## HISTORIC AND DESIGN REVIEW COMMISSION

October 20, 2021

**HDRC CASE NO:** 2021-501  
**ADDRESS:** 209 ALAMO PLAZA  
**LEGAL DESCRIPTION:** NCB 145 BLK LOT 5  
**ZONING:** D, H  
**CITY COUNCIL DIST.:** 1  
**DISTRICT:** Alamo Plaza Historic District  
**APPLICANT:** David Hannan/Fisher Heck Architects  
**OWNER:** Suzy Pack  
**TYPE OF WORK:** Installation of a storefront system, exterior modifications, repair and maintenance, canopy installation  
**APPLICATION RECEIVED:** September 28, 2021  
**60-DAY REVIEW:** Not applicable due to City Council Emergency Orders  
**CASE MANAGER:** Edward Hall  
**REQUEST:**

2 EAST EXTERIOR ELEVATION  
1/4" = 1'-0"

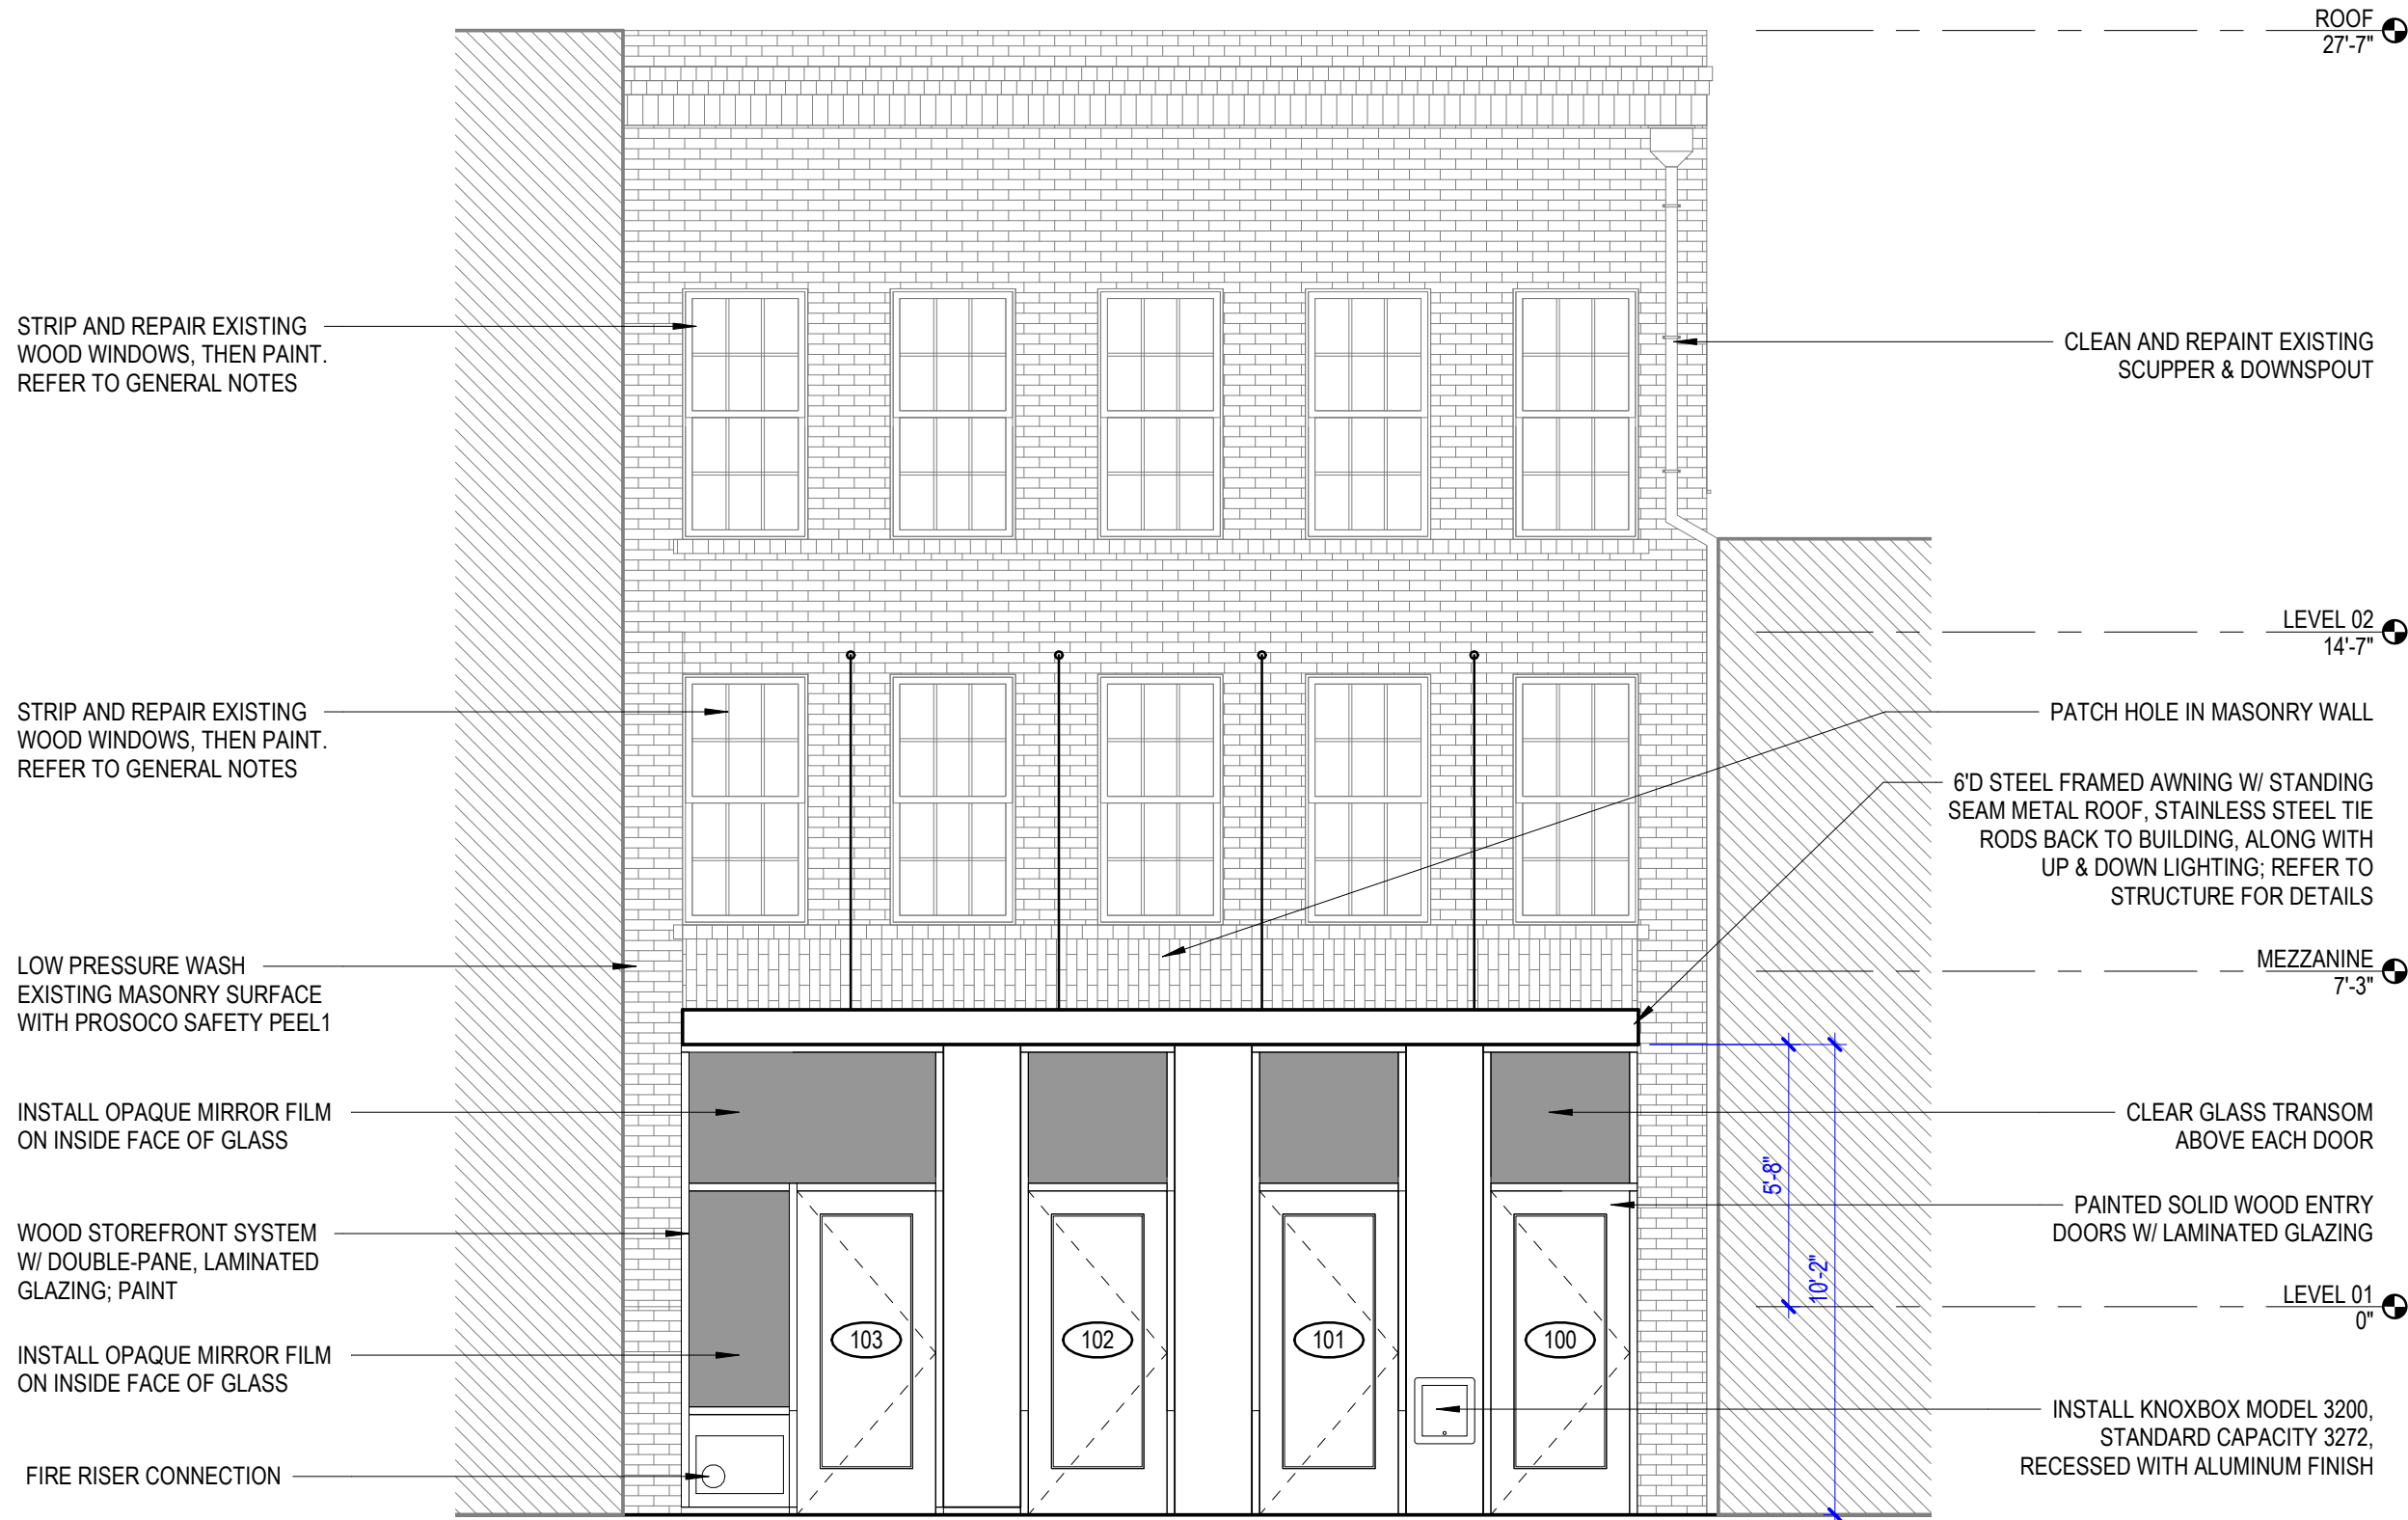
- d. CEMENT BOARD PONY WALL – The applicant has proposed to perform structural repairs to the existing pony walls, and in doing so, replace the existing finish of plaster with terra cotta tile. The Guidelines for Exterior Maintenance and Alterations 10.B.i., state that new features that alter or destroy the historic building character should not be introduced. Additionally, the Guidelines note that inappropriate materials should not be added. Staff finds the installation of terra cotta tile is not consistent with the Guidelines. Staff finds that the Guidelines should be followed regarding the historic façade, and that the scale, design, materials, color and texture of new materials should be compatible with those of the historic facade.

- 2. Staff does not recommend approval of item #2, the installation of terra cotta tile on the existing pony wall based on finding d. Staff recommends that the scale, design, materials, color and texture of new materials should be compatible with those of the historic facade. Additionally, staff recommends that the key box be relocated from a prominent location on the primary façade.

1 WEST EXTERIOR ELEVATION  
1/4" = 1'-0"

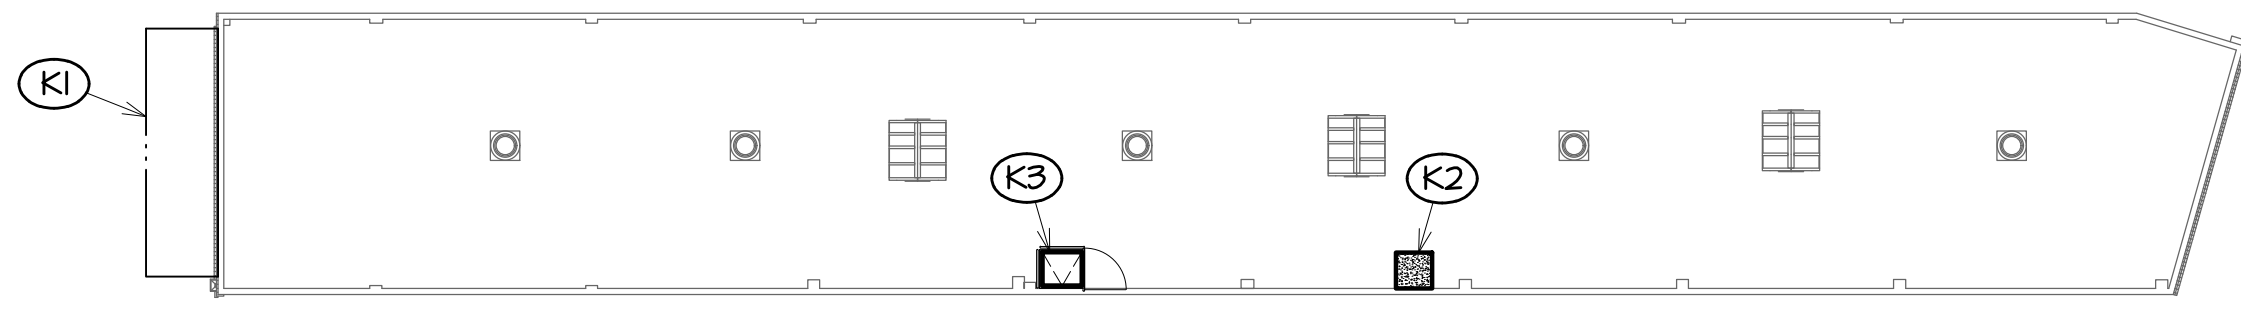
- e. STOREFRONT SYSTEM – The applicant has proposed to install a new, wood storefront system on the west façade to feature wood doors and a key box. The existing storefront system has been obscured by non-original building materials. The Guidelines for Exterior Maintenance and Alterations 10.B.ii. note that non-historic facades should be returned to their original design based on photographic evidence. When evidence is not available, the scale, design, materials, color and texture of new materials should be compatible with those of the historic façade. Staff finds that the proposed new storefront system should feature a profile that is not consistent with those found historically on this building or the block.

- 3. Staff does not recommend approval of item #3, the installation of a new storefront system as proposed. Staff recommends that a storefront system be installed that features a profile that is historically appropriate. Storefront openings, pony walls, mullions, and transom openings should be based on historic examples.

### NEW CANOPY FRAMING PLAN

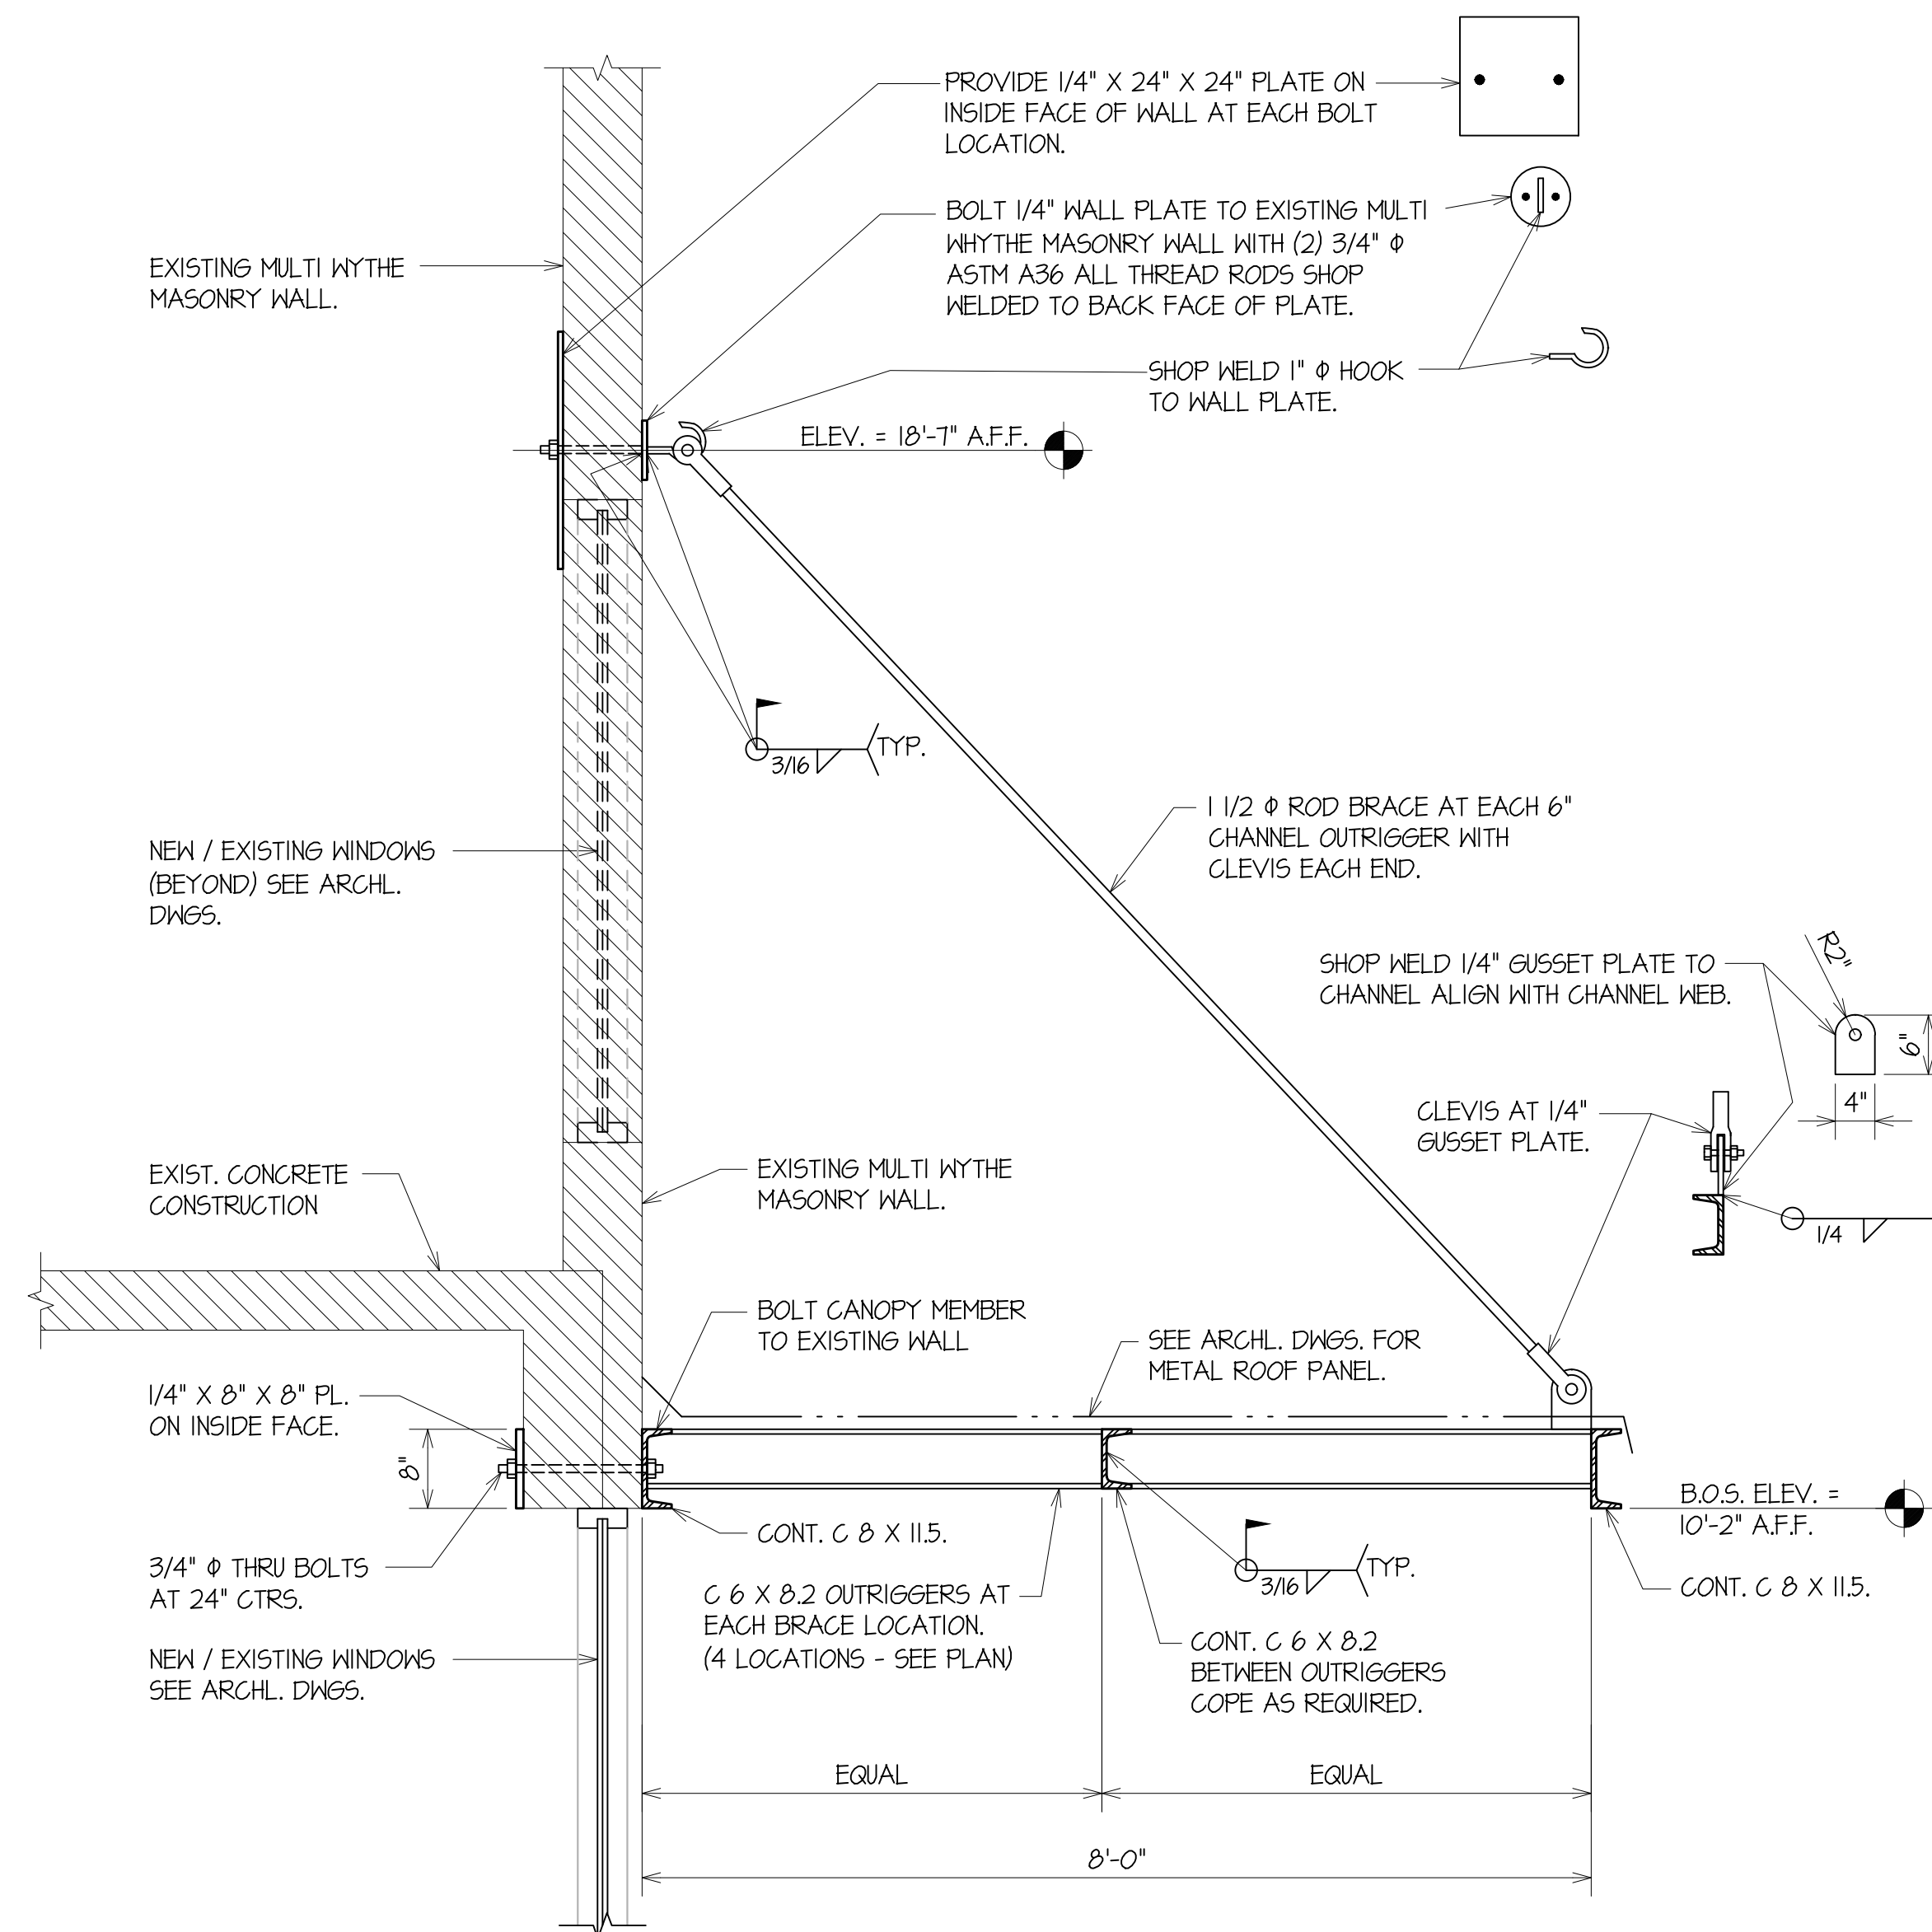
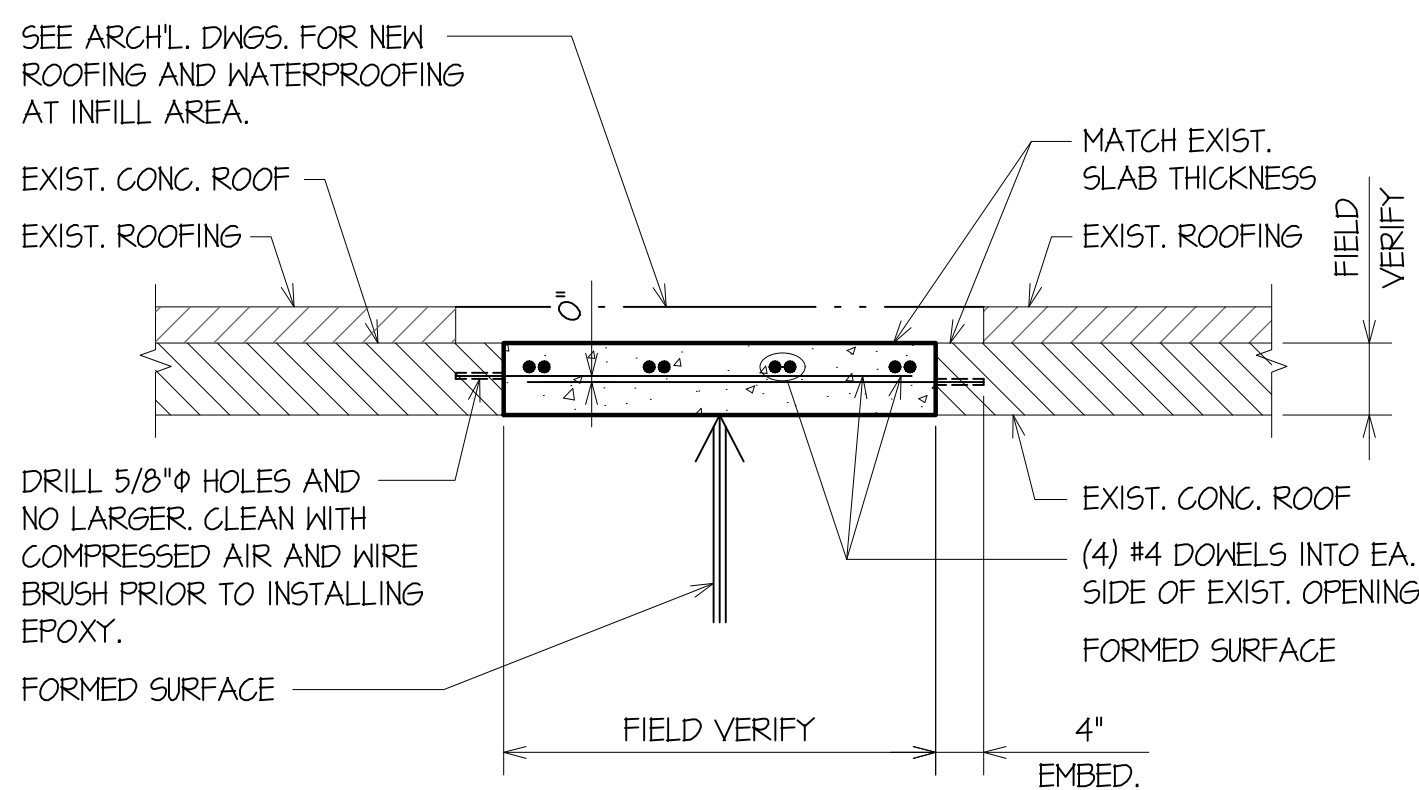
- f. CANOPY – The applicant has proposed to install a new steel framed canopy on the west façade. The Guidelines for Exterior Maintenance and Alterations 11.B.ii. notes that canopies should be added based on accurate evidence of the original, such as photographs. If no such evidence exists, the design of new canopies and awnings should be based on the architectural style of the building and be proportionate in shape and size to the scale of the building façade to which they will be attached. Generally, staff finds the installation of a canopy on the west façade to be appropriate; however, staff finds that the proposed height of the canopy is atypical with the historic placement of canopies, which are typically located above the storefront system and beneath transom windows. Additionally, staff finds that the proposed standing seam metal roof that is proposed for the canopy should feature smooth panels that are 18 to 21 inches in width, seams that are 1 to 2 inches in height, crimped ridges and a standard galvalume finish. Panels should not feature striations or corrugation. Lastly, staff finds the profile of the canopy, with an exposed steel beam to be atypical with historic canopy design. Staff finds that the proposed canopy should feature a profile that is consistent with historic canopy details. Canopy rod anchors should not be installed through the face of historic masonry.

- 4. Staff recommends approval of item #4, the installation of a new canopy with the following stipulations:
  - i. That the canopy's height be reduced to be placed consistently with historic examples; commonly immediately between the storefront system and transom windows.

- ii. That the proposed standing seam metal roof that is proposed for the canopy should feature smooth panels that are 18 to 21 inches in width, seams that are 1 to 2 inches in height, crimped ridges and a standard galvalume finish. Panels should not feature striations or corrugation.

- iii. That the proposed canopy should feature a profile that is consistent with historic canopy details, The exposed steel beam should be modified or covered.

- iv. That canopy rod anchors be installed in a manner that does not penetrate the face of existing masonry.
- 5. Staff recommends approval of item #5, roof hatch relocation with the stipulation that the existing roof and parapet wall profiles remain unchanged.
